DUKE COGEMA
STONE & WEBSTER

18 February 2003
DCS-NRC-000128

Subject: Docket Number 070-03098
            Duke Cogema Stone & Webster
            Mixed Oxide Fuel Fabrication Facility
            Responses to Financial Qualification, Fire Safety, Chemical Safety, Aqueous
            Processing, Material Processing and Ventilation Open Items/Additional NRC
            Questions on Construction Authorization Request (CAR) Revision

Responses to Financial Qualification, Fire Safety, Chemical Safety, Aqueous Processing, Material Processing and Ventilation Open Items/Additional NRC Questions on Construction Authorization Request (CAR) Revision

Evaporation Rate of a 50m² Pool of 13.6N Nitric Acid at Various Wind Speeds

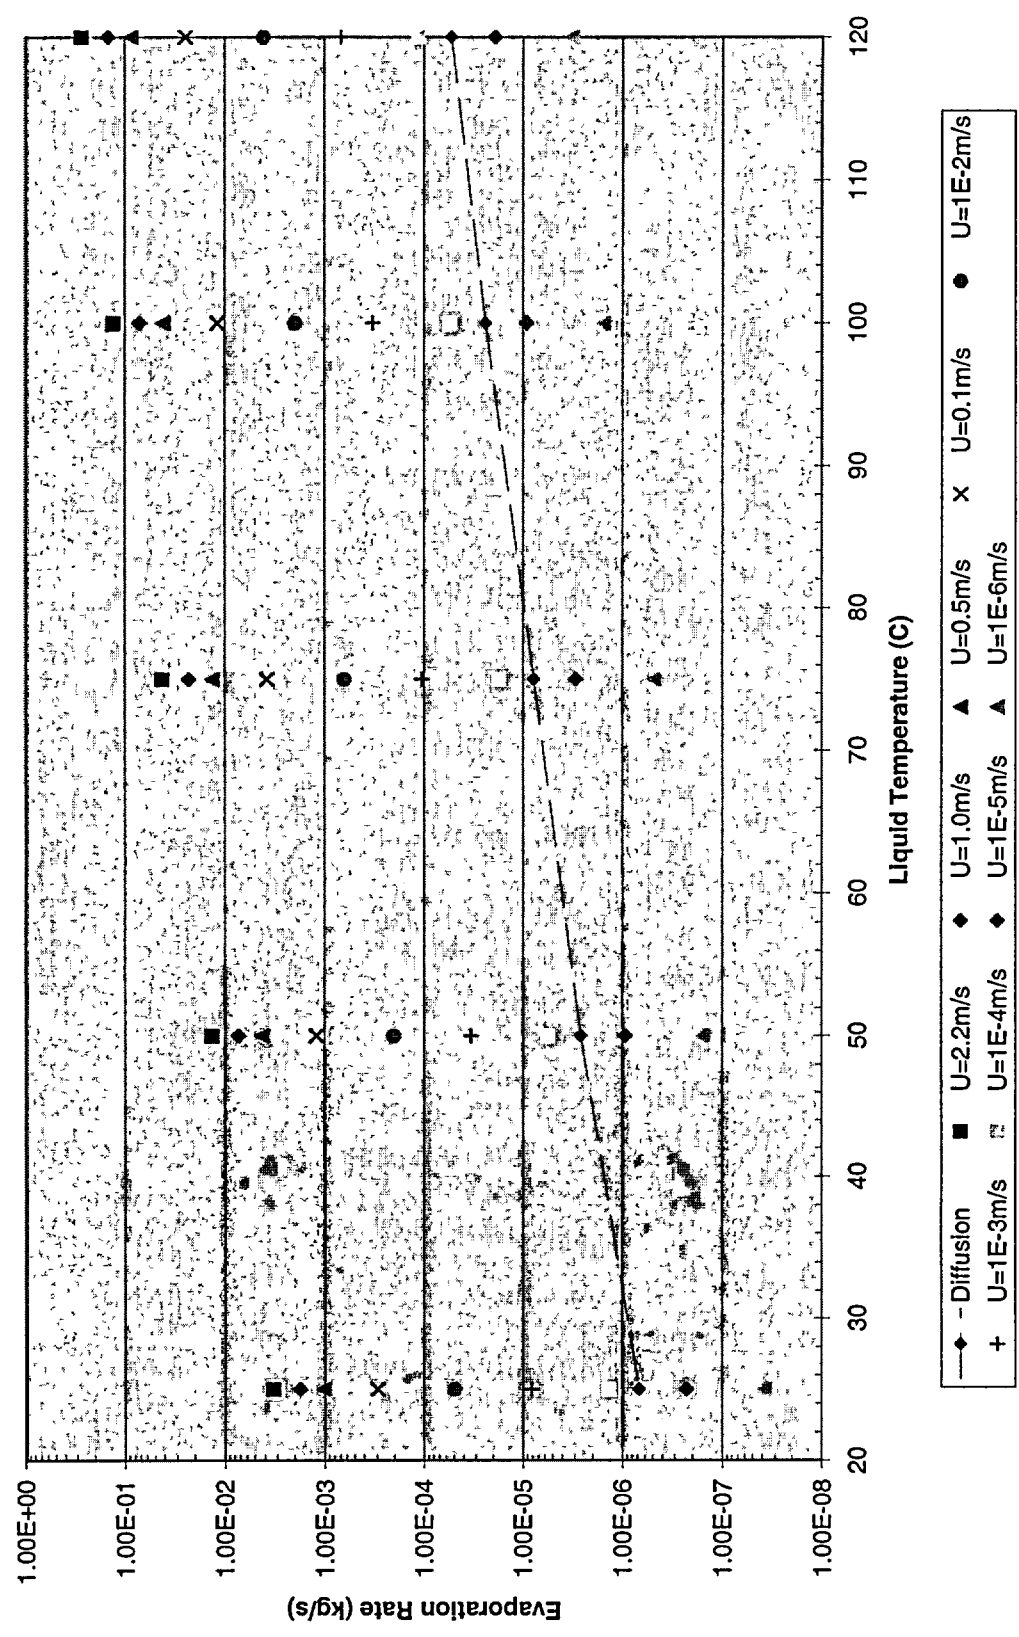
In a 22 January 2003 telecon, NRC requested information on the calculation approach used for evaluating the effects of indoor nitric acid spills to an external receptor (specifically, the applicability of the model at low wind speeds and if assumptions on wind speed were a design basis). The scoping studies of releases of nitric acid were performed at elevated temperatures from within the MFFF building to determine the impact to the site worker at 100 meters. The study modeled several releases under a variety of conditions and included parametric studies of nitric acid temperature and concentration, amount of material involved in the spill, size of the spill/room, and indoor wind speed. The 95[th] percentile outdoor X/Q was used to transport the release once the release reached the outside of the building. No credit was assumed for building holdup, dilution within the ventilation system, or cooling of the spilled solution to the

A final check was performed to assure that the diffusive evaporation rate (occurring at zero wind speed) did not exceed the evaporation rate produced by the ALOHA model at low wind speeds for high concentration nitric acid (13.6 N) at an elevated temperature of 120 °C. The attached figure shows that very low wind speeds ($< 10^{-4}$ m/s) are required to reach evaporation rates comparable to the diffusive evaporation rate.

This information indicates that the evaporation rate model used to assess the chemical consequences of leaks and spills inside the aqueous polishing building is applicable for the evaluated low indoor wind speeds.

Flammability Limits of Argon-Hydrogen in Air at 1 bar and temperatures as shown
Data from Chemsafe (C) DECHEMAe V.14 10 2002

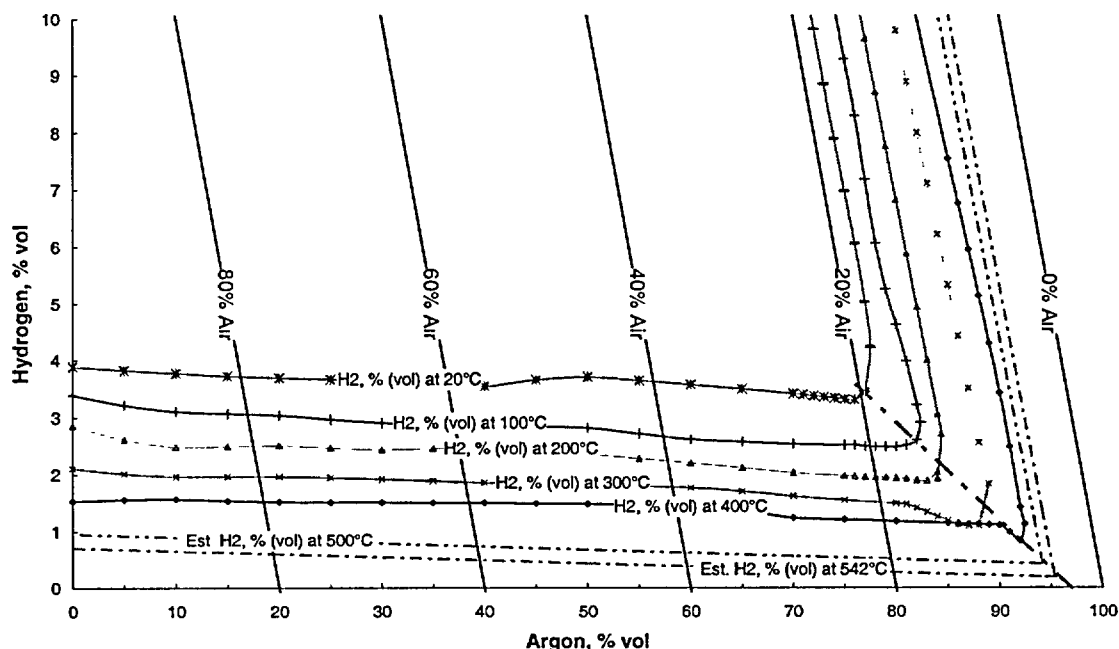
AP-02:   **With respect to the electrolyzer, the applicant's hazard and accident analysis did not consider fires and/or explosions caused by ignition of flammable gases generated by chemical reactions and/or electrolysis, such as from an overvoltage condition. This applies to the dissolution and silver recovery units (DSER Sections 11.2.1.2 and 11.2.1.10)**

Clarification of AP-02: Provide the lower flammability limit methodology and a Hanford report that supports the use of acid normality controls as design bases, as described at CAR 5.5.2.4.6.13.

To ensure that explosions are prevented within the Mixed Oxide Fuel Fabrication Facility (MFFF), the facility is designed such that 50% of the lower flammable limit (LFL) for combustible gases used, generated or evolved in the process is not exceeded outside of the process containment structures. In order to comply with this requirement, the systems are designed to dilute the accumulation of combustible gas to ensure that the concentration of combustible gas does not exceed 25% of the LFL or to take action when 25% of the LFL is reached. The safety threshold values of 50% and 25% LFL provide a sufficient margin to account for uncertainties in the actual LFL value and were chosen based on teaching from the National Fire Protection Association standards (principally NFPA 801-1998, NFPA-86-1995 and NFPA-86C-1995) and NUREG 1718. These values are based on LFL values that have been adjusted to account for changes in temperature, pressure and mixture composition.

An example of how these variations are used when determining an appropriate LFL value will be shown using hydrogen as the combustible gas. Pure hydrogen in air under standard reference conditions is flammable at concentrations between 4% (LFL) and 75% [upper flammable limit (UFL)] by volume. Mixtures that fall below the LFL are too lean to support combustion and mixtures that fall above the UFL are too rich to support combustion. The LFL and UFL values change under different conditions of temperature, pressure and gas composition. Because a higher risk is present when transitioning between lean and rich mixtures, the adopted safety

At the MFFF, pure hydrogen is not used, so an evaluation of the mixed gas must be performed to determine an appropriate LFL. Instead of pure hydrogen, the MFFF uses a gas mixture consisting mainly of the inert gas argon with a small percentage of hydrogen. The LFL for hydrogen is not sensitive to changes in pressure below 100 atm, so changes in the LFL due to small changes in the local atmospheric pressure are ignored when determining the LFL. However, the LFL is affected by the addition of argon and changes in temperature. These changes are shown for argon- hydrogen-air mixtures in the figure below.

The concentration of argon is shown on the abscissa (x-axis). The corresponding hydrogen concentration is the ordinate value at the point that the argon concentration value intersects the flammability limit line. Thus at 0% argon, the figure shows that the LFL for hydrogen at 20°C is 4% by volume (i.e., the standard value). At elevated temperatures, say 120°C, which could be the result of an accident, the LFL could be as low as 3.3% hydrogen by volume, when the gas composition also consists of 75% argon and 21.7% air. Because this scenario represents the worst case credible environmental conditions for a leak of the hydrogen-argon gas into the sintering furnace room, the LFL thresholds for this scenario would be set at 1.6% (50% LFL) and 0.8% (25% LFL).
